THE HANFORD SITE

Proposed Permit Modification for the 242-A Evaporator Operating Unit Group

Proposed Permit Modification Overview

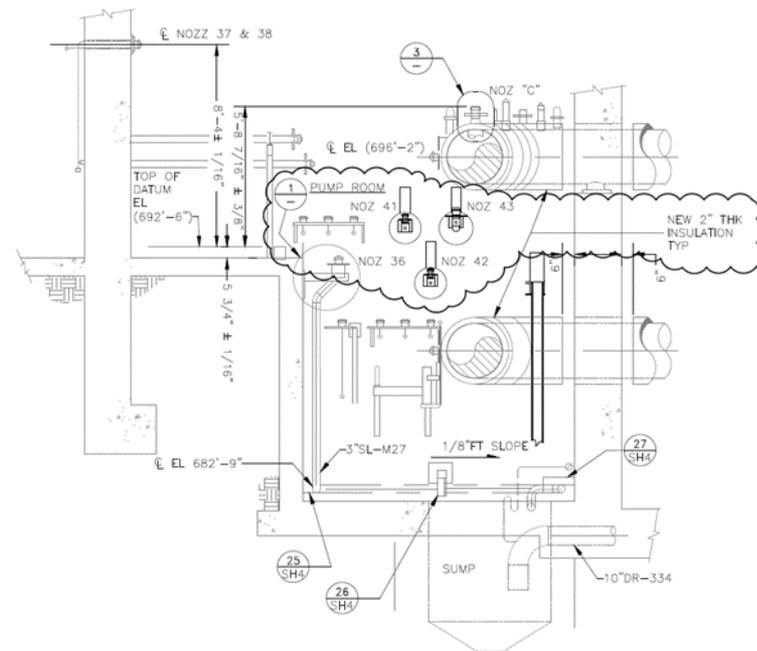
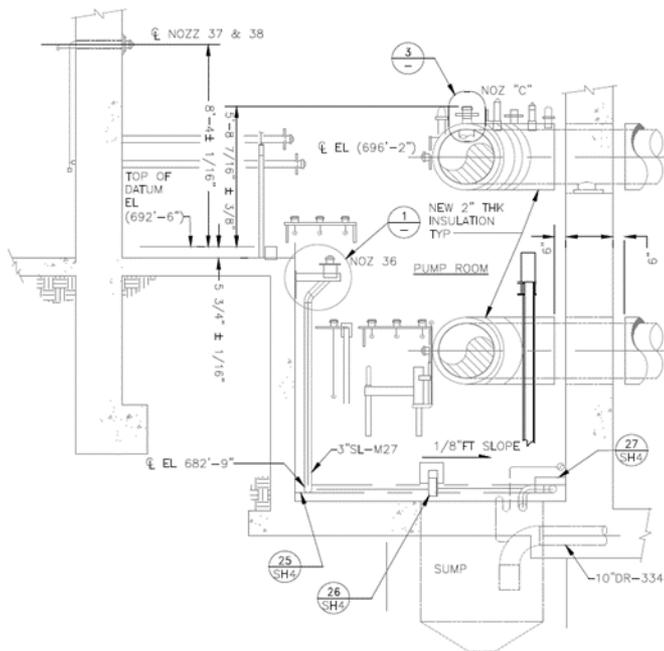
- A permit modification is needed to fulfill the requirements of WAC 173-303-830(4)(b)(iv) for a Class 2 permit modification.
- This proposed permit modification would allow for three new wall penetrations in the 242-A Evaporator facility to connect three new DST transfer lines.
- Permit modifications would allow for the following:
 - Isolation of existing feed and slurry transfer lines in 242-A Evaporator pump room
 - Installation of new wall nozzles
 - Installation of new jumpers

- Nozzle 41 – new 2-inch nozzle connection point to transfer line SL-170
- Nozzle 42 – new 2-inch nozzle connection point to transfer line SL-171
- Nozzle 43 – new 3-inch nozzle connection point to transfer line SN-275

Pump Room Nozzles With Variance Due to Secondary Containment Stopping at the Pump Room Outer Wall

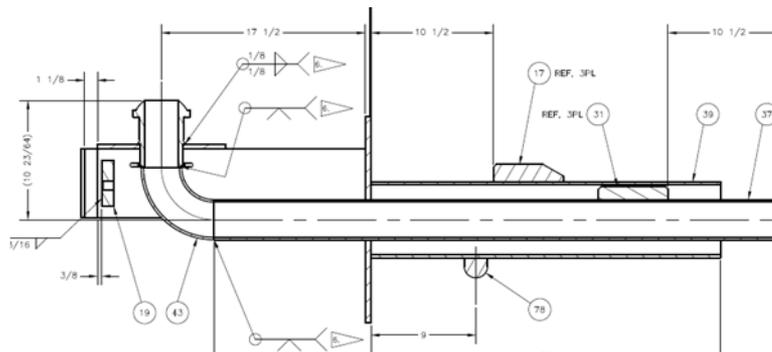
- New wall nozzle encasements will extend through the pump room wall to achieve compliant secondary containment
- The figures below show a comparison between wall nozzle configurations as they pertain to the encasement
- Nozzle size and orientation within the pump room are unchanged

Replacement Pump Room Nozzles With Secondary Containment Extending to the Inside of the Pump Room Wall.
